Dakota Access, LLC
Dakota Access Pipeline Project
Siting Application

Case No. PU-14-842

DATE: July 21, 2017
TO: The Commissioners
FROM: John M. Schuh and Sara Cardwell
RE: PU-14-842 Investigation Hearing

STAFF MEMORANDUM IN RESPONSE TO OPENED INVESTIGATION

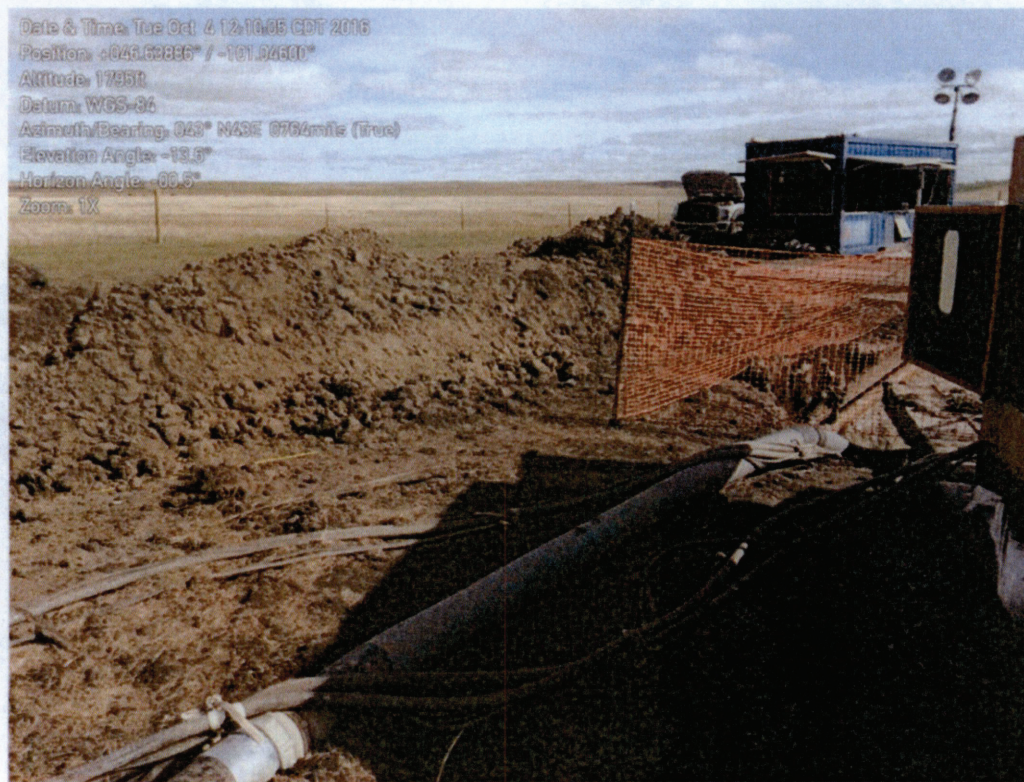
A 26 September 2016 inspection by Keitu found long stretches of ROW (100'+) where topsoil was not adequately stripped to the required depth. Subsoils were used for grading over these improperly stripped areas. A ROW easement for topsoil storage was not properly stripped and subsoils from the trench were stacked/mixed in with the topsoil. It was suggested that land reparations should be considered for improper segregation.⁴⁹ The landowner was actively involved with this inspection and has experience working with land and soil reclamation. He stated that an onsite mechanic told him stripping and grading crews were running slower than tie-in crews. He believes this to be the reason for improper ROW stripping. He also stated that he received an estimate of approximately \$400,000 to fix the inadequate segregation.

[T]he condition of the Dakota Access Pipeline (DAPL) Right-of-Way (ROW) is significantly below the standards the project successfully demonstrated in other locations of the project. The top soil stockpiles are extremely small given the unusually wide ROW dimensions associated with this project and the expectation that a minimum of 12 inches of topsoil, where available be removed and stockpiled outside of the active work zones. As the photos show, there is clear evidence additional topsoil remains within the work zone.⁵⁰

In a March 23, 2017 response letter, Mike Futch stated that the “[i]t appears there is a difference of opinion between the Commission’s third party inspector and other standards in the industry regarding topsoil stripping, segregation, and handling procedures.” Mr. Futch also provided a technical memorandum in response to the third party construction inspector in an attempt to clarify the issues.⁵¹

In the technical report prepared by Aaron Dejoia, a North Dakota Certified Professional Soil Classifier, Duraroot Environmental Consulting, LLC stated that although topsoil depth can be evaluated differently by different soil scientists, “given the shallow topsoil depths for this location, per the NRCS soil survey, and the similar colors and characteristics of the underlying subsoil, it appears that the topsoil segregation was appropriately handled in the majority of the area” and that as observed by the data

presented, "topsoil was salvaged to appropriate depths throughout the majority of the ROW."⁵²

Staff spoke with Dean Moos, Director of Reclamation and a registered soil classifier regarding the photos. Mr. Moos reviewed the photographs, order requirements of Provision 16, and the response by Duraroot Environmental. From Mr. Moos's review, he believes that there is a violation of provision 16 of the order.

Report Photo #3 "No Straw Mulch Visible Under Bore Pit's Subsoil Pile:

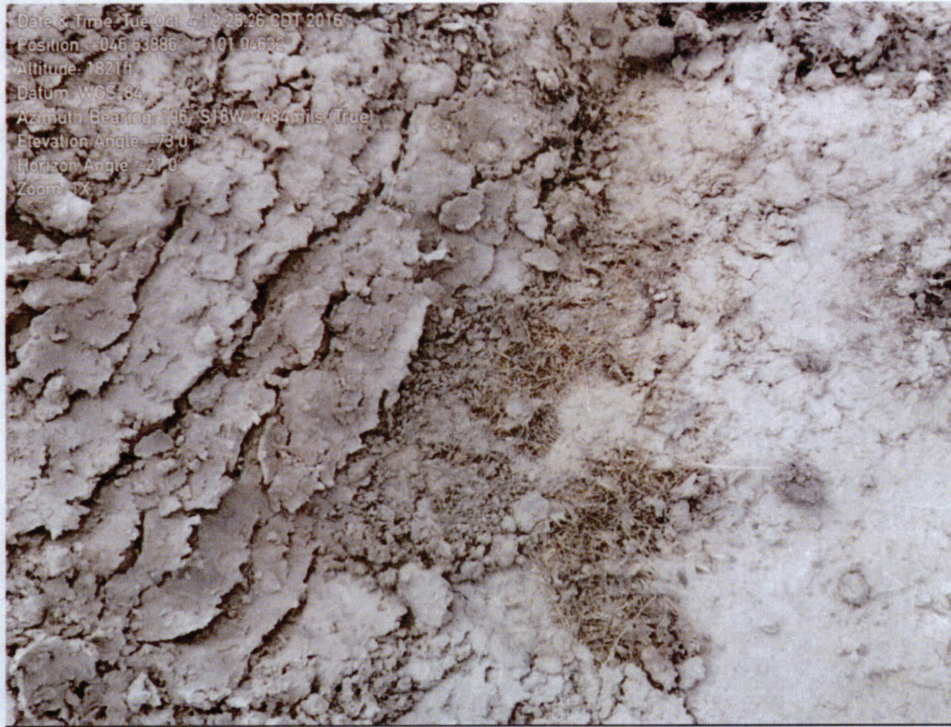
An inspection showed that subsoil piles from trenching were bordering and overlapping with the topsoil pile and subsoil was stored over unstripped ground. The lead inspector claimed he was advised by an Ag inspector to place straw mulch under the pile when piling on topsoil. However, straw mulch was not visible during the site visit in these areas. Rainfall appeared to have caused much of the overlapping. Two areas had subsoil cast on or plowed onto adjacent topsoil for a limited duration.⁵³
